Work Order ID 95322

Item Name: Crosstube Turning DetailL

DART AEROSPACE LTD	Work Order:	95322
Description: Crosstube Assembly (206L High Fwd)	Part Number:	D206-667-143
Inspection Dwg: D206-667-143 Rev: C		Page 1 of 2

DRAWING NO. D206-667-143	TITLE CROSSTUBE ASS'Y (206L HIGH FWD)	REV. C	DART AEROSPACE LTD ENGINEERING ORDER		D.E.O. NO. D206-667-143-C-1	SHEET NO. SHEET 1 OF 1	SCALE NTS
DRAWN 97	CHECKED ASS	MFG. APPR. [Signature]	APPROVED [Signature]	DE APPR. [Signature]			
DATE 11.07.15	DATE 11.07.20	DATE 11.07.21	DATE 11/07/21	DATE 11.07.21

DETAIL P
BONDING STRAP INSTALLATION 2 PL

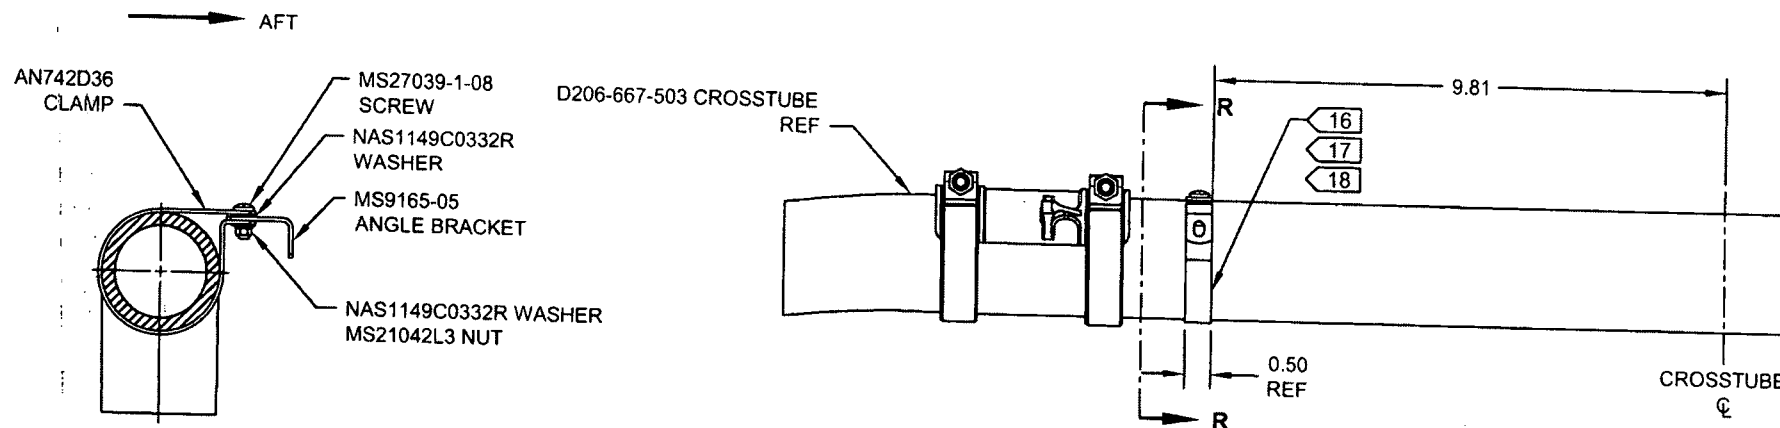
ADD ELECTRICAL GROUNDING STRAP

ITEM	QTY -143	PART NUMBER	DESCRIPTION
1	X	D206-667-143	CROSSTUBE ASSEMBLY (206L HIGH FWD)
⚡			
10	2	AN742D36	CLAMP
11	2	MS9165-05	ANGLE BRACKET
12	2	MS21042L3	NUT (OR MS21042-3)
13	2	MS27039-1-08	SCREW
14	4	NAS1149C0332R	WASHER (OR AN960C10L)

- 16) MASK AREA UNDER CLAMP PRIOR TO PAINTING
- 17) SEAL EDGES WHERE AN742D36 CLAMP MEETS WITH THE CROSSTUBE USING SIKAFLEX-241/-291 OR MIL-S-8802 CLASS B2 OR PROSEAL 890 SEALANT
- 18) PERFORM RESISTANCE CHECK TO ENSURE MAX RESISTANCE IS 10 MILLIOHMS
